To: City Engineering Division, Department of Public Works Survey Bureau(Through Channels)  
Subject: **NOTICE OF PROPOSED CHANGE IN PROPERTY PETITION X126**  
From: Sergeant Sherley Bledsoe badge S371, Twelfth Precinct

This proposed change to outright vacate part of the east/west public alley, 16ft.WD in the block bound by Schafer Highway, Outer Dr., Hartwell Avenue and Santa Maria Avenue abutting lots 1, 2 and 6.

<b>B</b>					<b>REQUEST TO OUTRIGHT VACATE PART OF          THE EAST/WEST PUBLIC ALLEY, 16 FT.WD          IN THE BLOCK BOUND BY          SCHAEFER HIGHWAY, OUTER DR., HARTWELL AVE.          AND SANTA MARIA AVE.          ABUTTING LOTS 1, 2 AND 6</b>	<b>CITY OF DETROIT</b> CITY ENGINEERING DEPARTMENT SURVEY BUREAU																				
<b>A</b>						JOB NO. 01-01

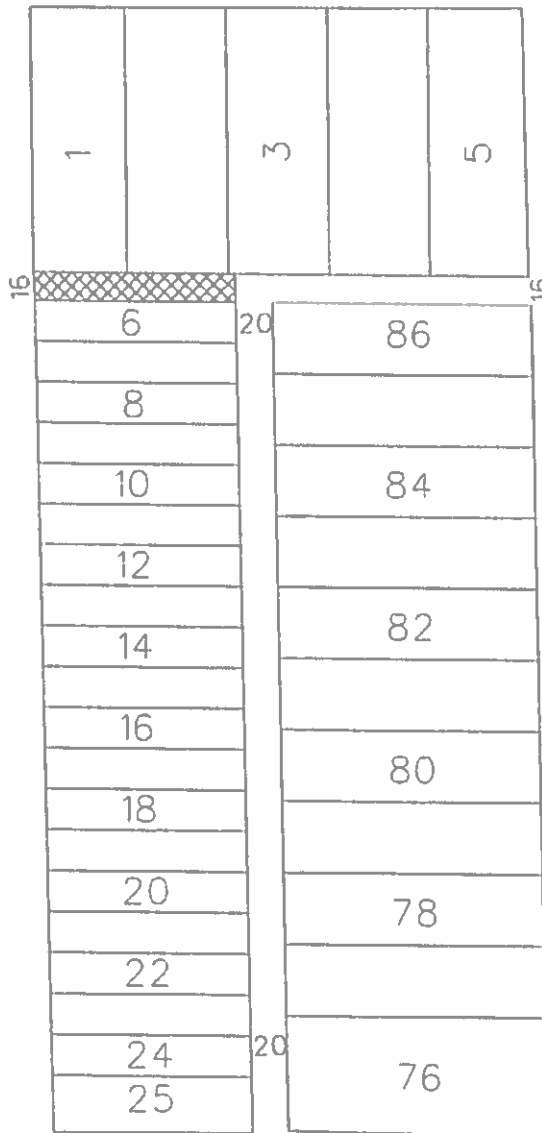
To vacate this area would be to block half of the alley I and the emergency vehicles would not have access to the area if needed. Currently this location allows for emergency vehicles to have access from Hartwell Avenue through to Schafer Highway. Vacating /Closing off this area would cause hardship for emergency vehicles.

\* I CONCUR WITH SERGEANT BLEDSOE'S OBJECTION TO THIS PROPERTY CHANGE.  
CPT JOEL L. TUCKER, JR  
15<sup>TH</sup> PRECINCT
